Subject: Comments and questions for Docket 3717 80 Broadway

Subj: Docket #3717 80 Broadway

I would like to submit the following questions for the applicant regarding the latest plans for 80 Broadway.

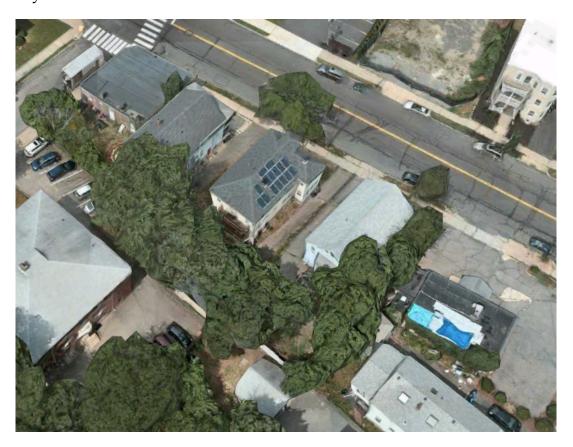
3. Could the applicant provide the detailed numbers that support the declaration of only 7,243 sf of residential gross floor area?

The 1st floor residential lobbies, staircases, etc comprise at least 800 sf.

The 2nd floor residential area is approx 1900 sf.

The 3rd and 4th floor residential areas are each 3054 sf.

The 5th floor residential area is approx 1500 sf

Total residential gross floor area is approx 10,300 sf, not 7234 sf as calculated by applicant. Does the applicant understand that total residential area is not just the sum of the interior apartment units but also includes hallways, stairwells, elevators, etc?
